Name of Proceeding: ACRS Thermal Hydraulic  
Phenomena and Future Plant  
Designs Subcommittee Meeting  
Docket Number: (Not Applicable)  
Location: Rockville, Maryland

## **Joint meeting of the Sub-committees on Future Plant Designs and T/H Phenomena**

**AP1000 Pre-Certification Review**  
*Presentation to the*  
**Advisory Committee on Reactor Safeguards**  
**Combined Thermal-Hydraulic Phenomena /**  
**Future Plant Designs Subcommittee Meeting**

# EFFECT OF $x_{AF}$

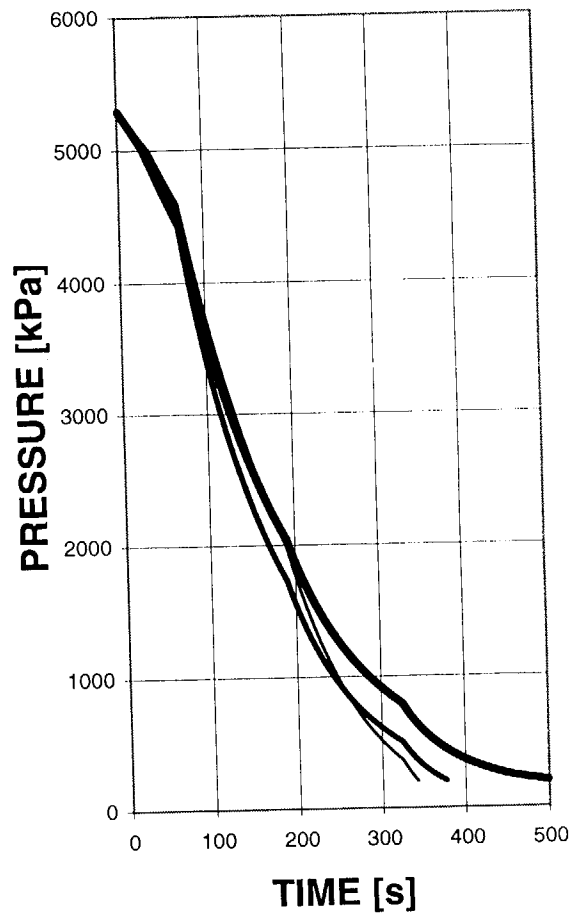
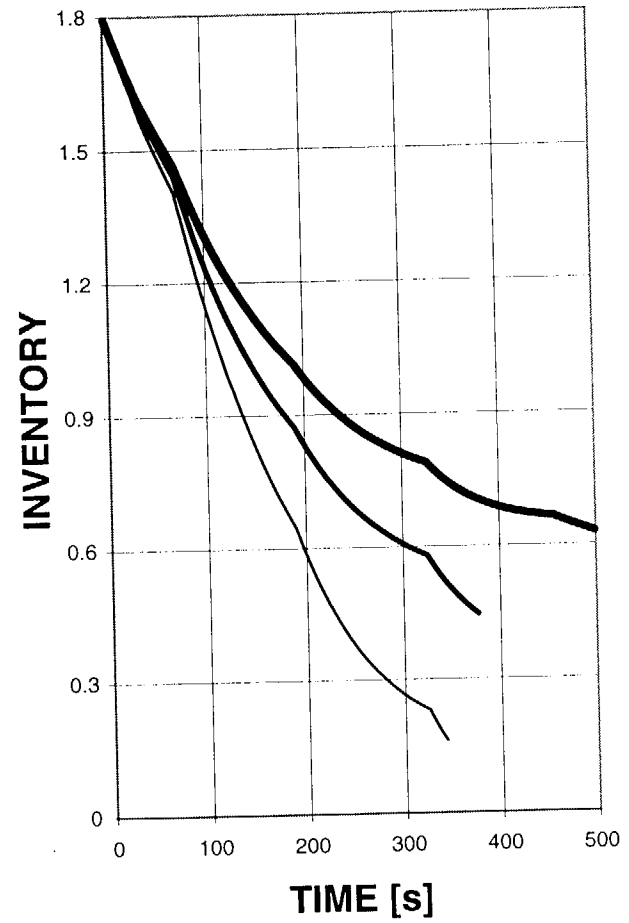
10 What if the quality of the ADS-4 is  
11 different? What is the impact of that on the figure  
12 of merit?

13 Now, this is very deceiving because of you  
14 look at the pressure trace, and you compare the  
15 pressure traces for different qualities, they  
16 basically are the same curve. They're not going to  
17 change much, and this is due to the competing effect.

18 It took me a while to figure it out, but  
19 basically what happens here is that if you were to  
20 decrease the quality, your pressure stays aloft more  
21 in the initial part because you lose liquid rather  
22 than vapor. But then you have lost basically all of  
23 the liquid. So basically your stored heat goes down  
24 the drain.

4 But if you look at inventory, meaning how  
5 much shorter you are left with for injection, that's  
6 a completely different answer. There there is a  
7 tremendous impact.

- The pressure behavior of the AP1000 for decreasing quality of the ADS discharge is quite complex. There are two of phenomena that compete with each other:
  1. A lower quality of the ADS discharge flow affects the heat removal and therefore decreases  $dp/dt$  early on
  2. Later in the transient, the residual system compliance increases  $dp/dt$  since the residual inventory is significantly reduced for lower qualities of the ADS discharge

### **■ Concerns & observations from “top-down” scaling:**

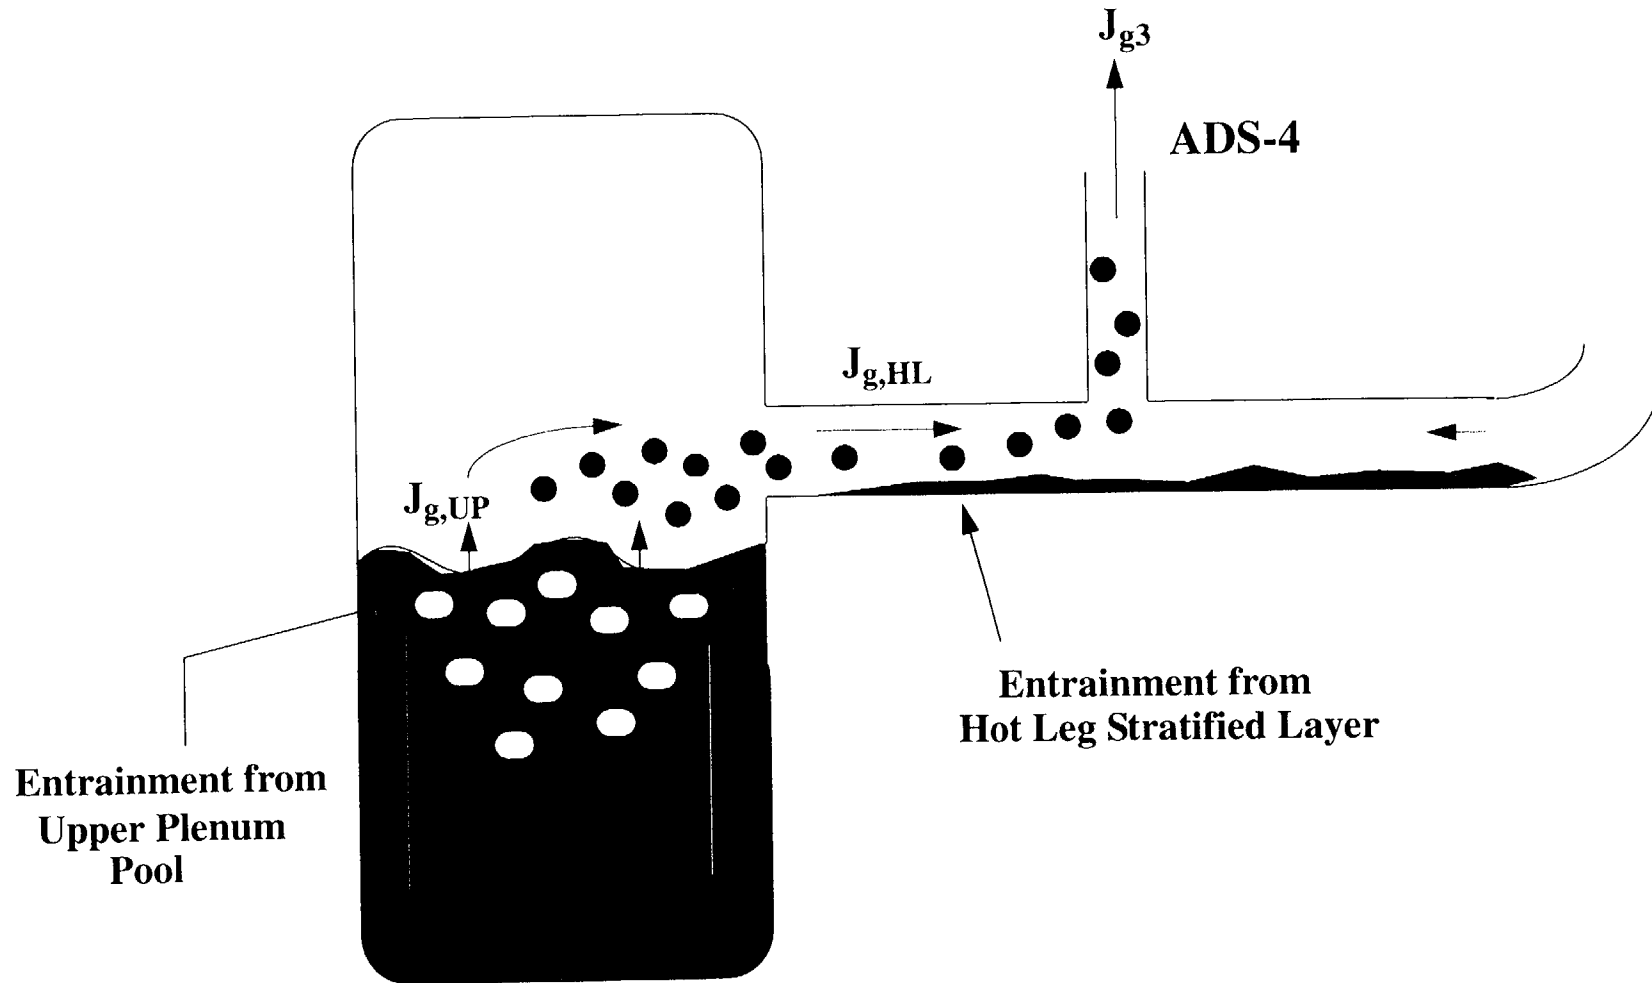
- ◆ INEL methodology assumes same ADS-4 flow quality in AP1000/AP600 and in the IETs.**
- ◆ Scaling groups in Intermediate through IRWST Injection periods show sensitivity to ADS flow quality.**

- Entrainment from Hot Leg Stratified Layer
- Westinghouse approach used typical correlation for entrainment onset:

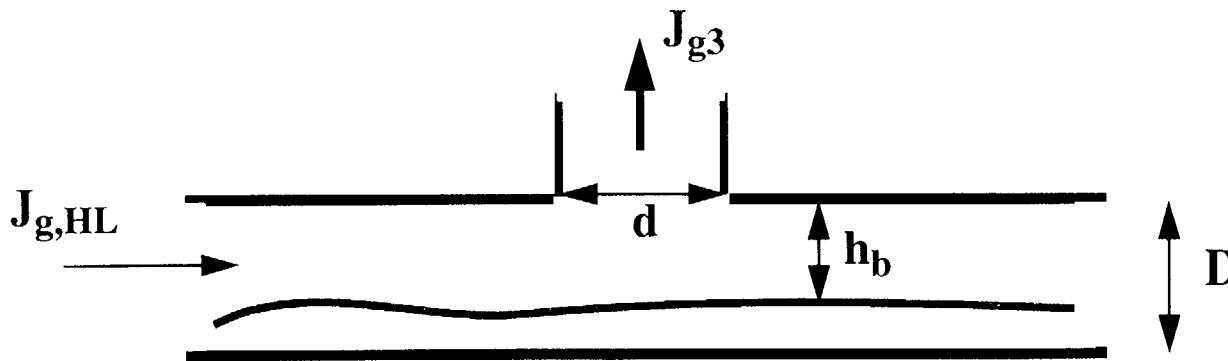
- ◆ **Problems with horizontal-stratified onset correlation(s) of the form,**

Figure A. Expected hot leg flow patterns in IRWST Injection period.

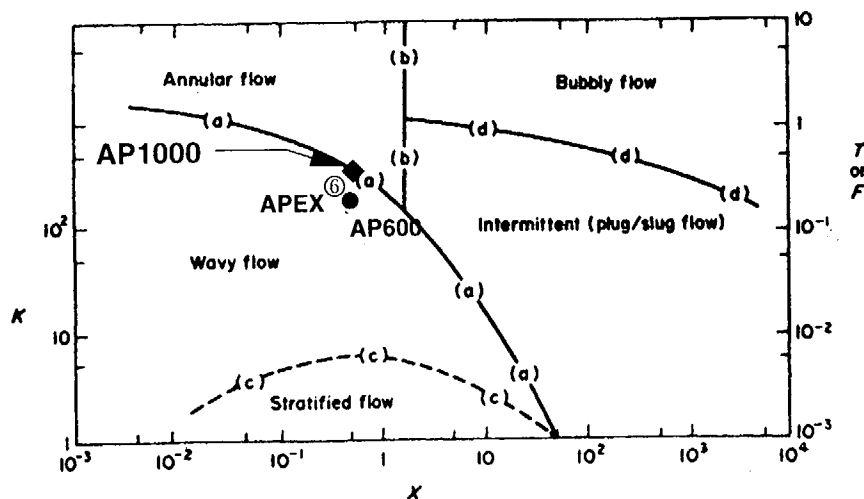
6 CO-CHAIRMAN WALLIS: But again, I get back  
7 to the question: how do you know  $h_b$ ? It isn't going  
8 anywhere. So how can you calculate horizontal  
9 stratified flow? It's just sitting in this hot leg  
10 sloshing around, waiting to be entrained. There's no  
11 stratified flow. It's just a pool of liquids.

- ◆ Consider annular flow, where roll wave entrainment expected - Typical correlation for critical entrainment velocity has form

- ◆ Hot leg entrainment expected for AP1000, but not for AP600 or IETs.
